ECE/TRANS/WP.29/GRSG/2009/2
3 February 2009

REGULATION No. 107
(M₂ and M₃ vehicles)

Proposal for further amendments

Submitted by the expert from the International Organization of Vehicle Manufacturers */

"Figure 5

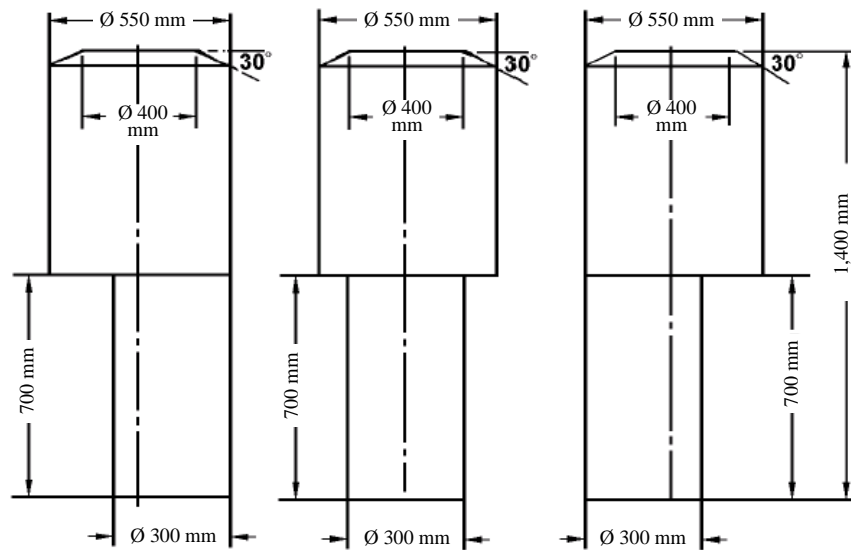
Figure 5, amend to read:

The base of the first cylinder shall be within the projection of the second cylinder. "

To add footnote which is moved from Annex 3, paragraph 7.7.2.2.

"Figure 6

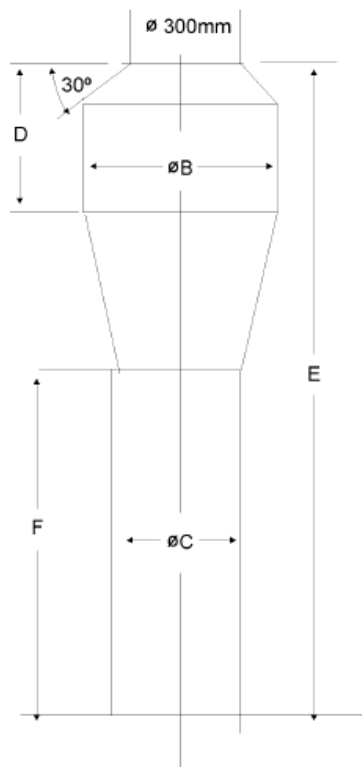
Figure 6, amend to read:

Single deck						
Class		B (mm)	C (mm)	D (mm)	E (mm)	F (mm)
A		550	350	500 (4/)	1,900 (4/)	900
B		450	300	300	1,500	900
I		550	450 (3/)	500 (4/)	1,900 (4/)	900
II		550	350	500 (4/)	1,900 (4/)	900
III		450	300 (2/)	500 (4/)	1,900 (4/)	900
Double deck						
I	LD	550	450 (3/)	500	1,800 (1/)	1,020 (1/)
	UD	550	450(3/)	500	1,680	900
II	LD	550	350	500	1,800 (1/)	1,020 (1/)
	UD	550	350	500	1,680	900
III	LD	450	300 (2/)	500	1,800 (1/)	1,020 (1/)
	UD	450	300 (2/)	500	1,680 1,800	900

To correct an error to dimension "E" for Class III double deck vehicles, which was introduced in the 02 Series of amendments.

"Figure 8

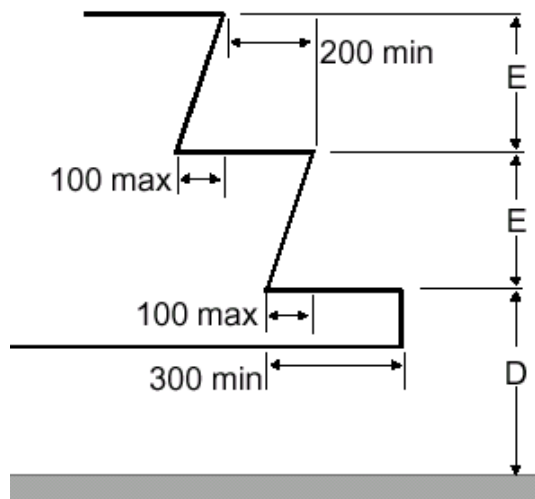
Figure 8, amend to read:

- (*) 230 mm for vehicles of Class A or B having a capacity not exceeding 22 passengers.
- (1) 700 mm in the case of an emergency door.
1,500 mm in the case of an emergency door in the upper deck of a double deck vehicle.
850 mm maximum in the case of an emergency door in the lower deck of a double-deck vehicle.
- (2) 430 mm in the case of a vehicle with solely mechanical suspension.
- (3) 300 mm in the case of steps at a door behind the rearmost axle.
- (4) 250 mm in gangways for vehicles of Class A or B having a capacity not exceeding 22 passengers.
- (5) For at least one service door; 400 mm for other service doors.

Standardisation on Class of vehicles and not on the number of passengers.
